TECHNICAL SERVICE BULLETIN

Media Bin Not Opening Consistently

26-2013

Ford 2025 Explorer

Figure 1

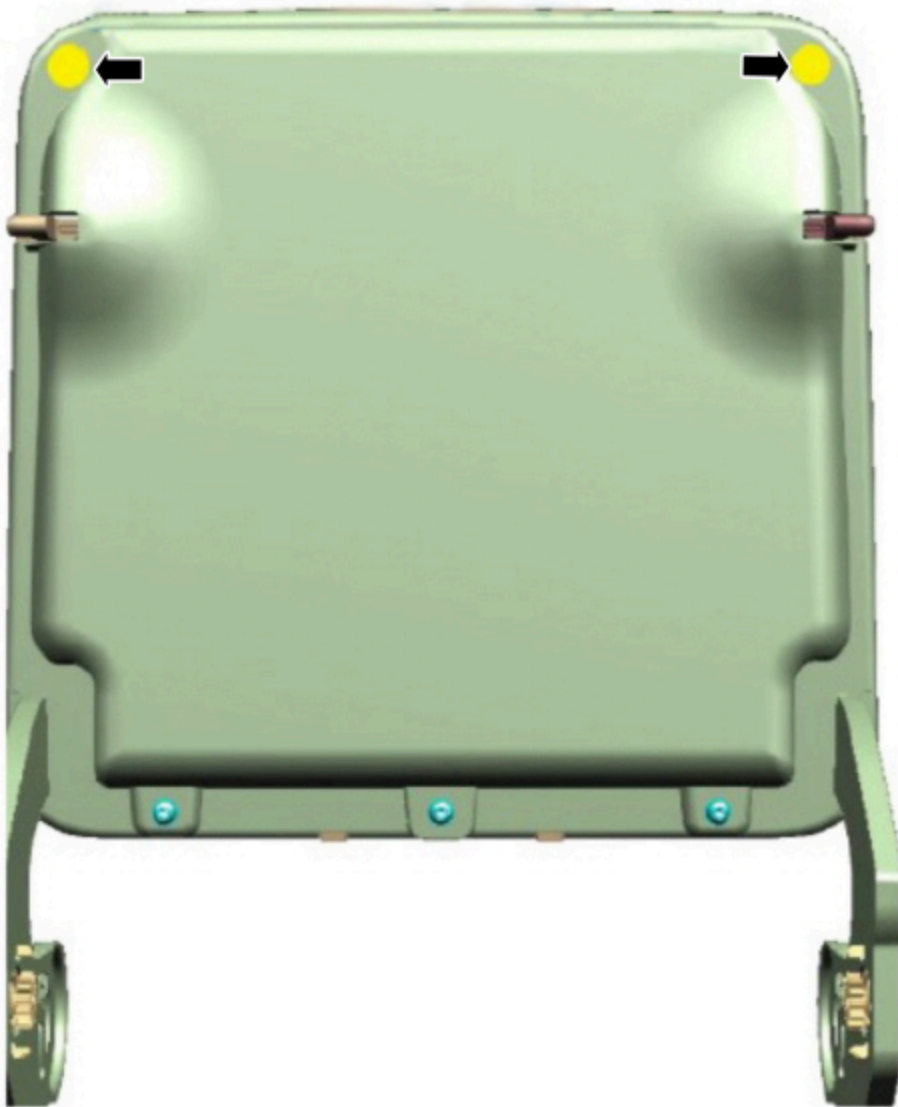
1. Clean the underside corners of the media bin door using a lint-free wipe and isopropyl alcohol to prepare the surface. Allow the area to fully dry before installing the round self-adhesive pads.
2. Open the media bin door. Install the new round self-adhesive pads on the underside corners of the media bin door lid, aligned with the existing lower pad location. (Figures 1-2)

3. Make sure the new round self-adhesive pads on the media lid touch the top of the existing pad location when closing the lid.
